The amendment revises the heatup and cooldown Technical Specifications (TS). In addition, editorial corrections and minor administrative changes are made to the TS. This action completes our TAC No. 61411.

KEWAUNEE NUCLEAR POWER PLANT

Amendment No. 70
License No. DPR-43

SAFETY EVALUATION BY THE OFFICE OF NUCLEAR REACTOR REGULATION
SUPPORTING AMENDMENT NO. 70 TO FACILITY OPERATING LICENSE NO. DPR-43

KEWAUNEE UNIT NO. 1 COOLANT HEATUP LIMITATION CURVES
 APPLICABLE FOR PERIODS UP TO 15 EFFECTIVE FULL POWER YEARS

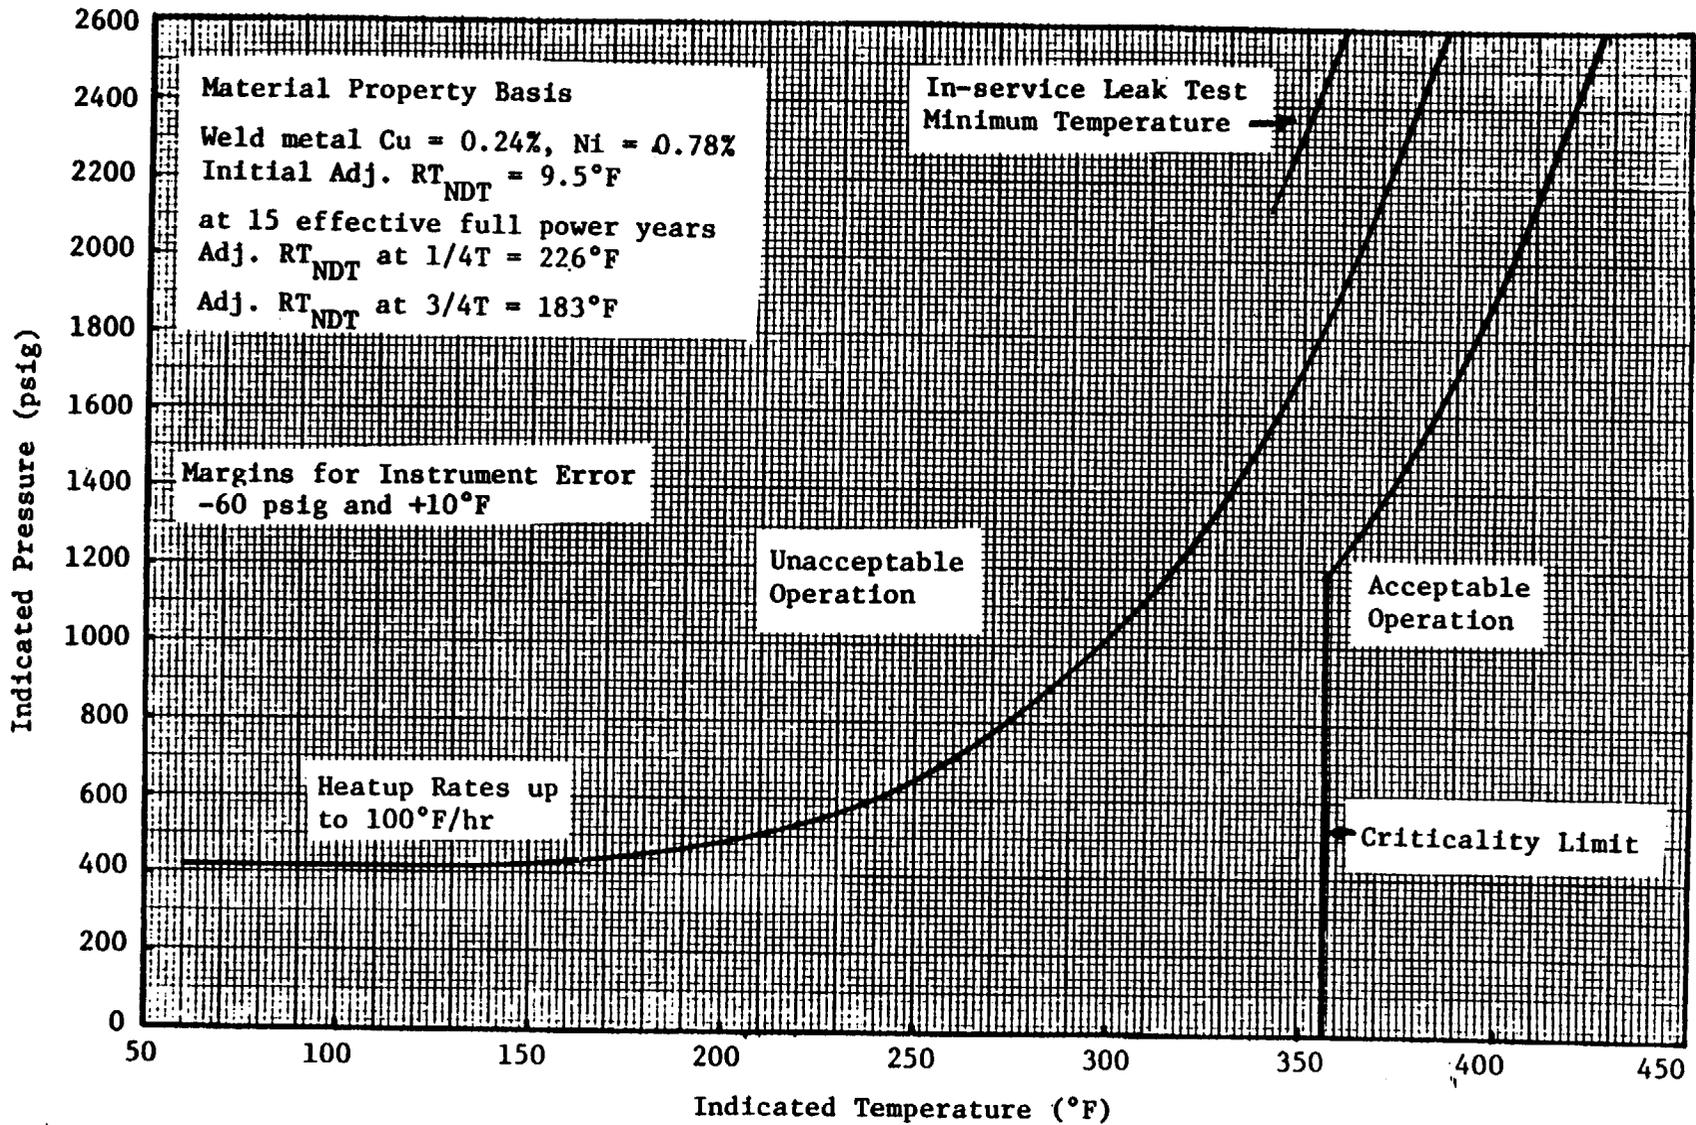
1. The reactor coolant temperature and pressure and system heatup and cooldown rates (with the exception of the pressurizer) shall be limited in accordance with Figures TS 3.1-1 and TS 3.1-2 for the service period up to 15 equivalent fullpower years.

The results of Irradiation Capsules V and R analyses are presented in WCAP 8908 and WCAP 9878, respectively. Heatup and cooldown limit curves for normal operation of the reactor vessel are presented in Figures TS 3.1-1 and TS 3.1-2 and represent an operational time period of 15 effective fullpower years.

The staff has used the method of calculating pressure-temperature limits in USNRC Standard Review Plan 5.3.2, NUREG-0800, Rev. 1, July 1981 to evaluate the proposed pressure-temperature limits. The amount of neutron irradiation damage was calculated using design basis calculated neutron fluences and the Regulatory Guide 1.99, Rev. 2, prediction method. Our conclusion is that the proposed pressure-temperature limits as shown in T.S. Figures 3.1-1 and 3.2-2 meet the safety margins of Appendix G, 10 CFR Part 50 for at least 15 EFPY, and the changes to T.S. Section 3.1(b) and bases are acceptable.
